Access Compliance Report

Public Rights-of-Way

(Curb Ramps)

Intersection ID: 13600	Main Street: 3RD-4TH_CONNECTOR_ST	Cross Street: E_4TH_ST	Location: E
ADA ID: 382915EB96F2	Ramp Type: Perp	Initial Pass/Fail: Fail	Overall Compliance: No
Severity Score: 21.25			
Codes/Mitigation Info/Possible Solution		Field Measurements/Component Compliance

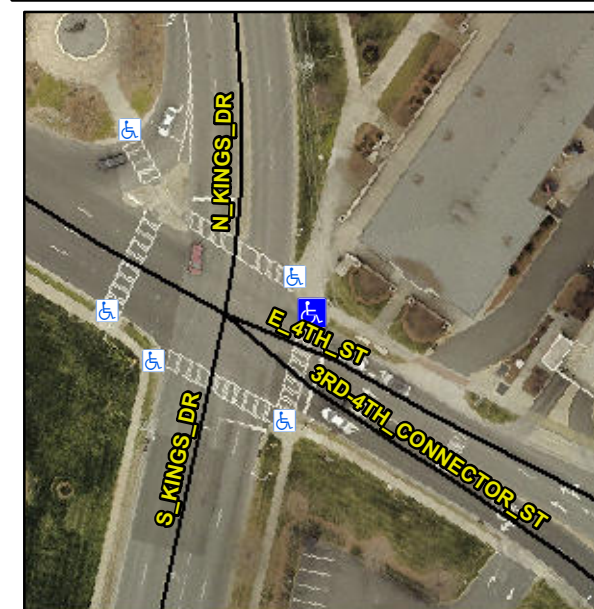
Not Found, R304.5.1, R304.2.2

Compliance	Description	Data	Compliance	Description	Data
N/A	Ramp Length (in)	72.0	No	Ramp Slope (%)	9.0
No	Ramp Width (in)	47.0	Yes	Ramp XSlope (%)	1.5
N/A	Flare Type LT	N/A	N/A	Flare Type RT	N/A
N/A	Flare Slope LT (%)	N/A	N/A	Flare Slope RT (%)	N/A
N/A	Flare Traversable LT?	N/A	N/A	Flare Traversable RT?	N/A
N/A	Landing Length (in)	N/A	N/A	DWS Provided?	N/A
N/A	Landing Width (in)	N/A	N/A	DWS Contrast?	N/A
N/A	Landing Slope (%)	N/A	N/A	DWS Length (in)	N/A
N/A	Landing X Slope (%)	N/A	N/A	DWS Full Width?	N/A
N/A	Landing Curb? (Y/N)	N/A	N/A	DWS Offset (in)	N/A
N/A	Shared Landing?	N/A			
N/A	Gutter Ponding?	N/A	N/A	Gutter Slope (%)	N/A
N/A	Gutter Lip Ht (in)	N/A	N/A	Gutter X Slope (%)	N/A
N/A	Painted X Walk1?	Yes	N/A	Painted X Walk2?	N/A
	X Walk 1 Direction	To SW		X Walk 2 Direction	N/A
N/A	X Walk 1 Width (in)	106.0	N/A	X Walk 2 Width (in)	N/A
	X Walk 1 Slope (%)	3.0		X Walk 2 Slope (%)	N/A
	X Walk 1 X Slope (%)	2.0		X Walk 2 X Slope (%)	N/A

Remove & Replace Entire Ramp.
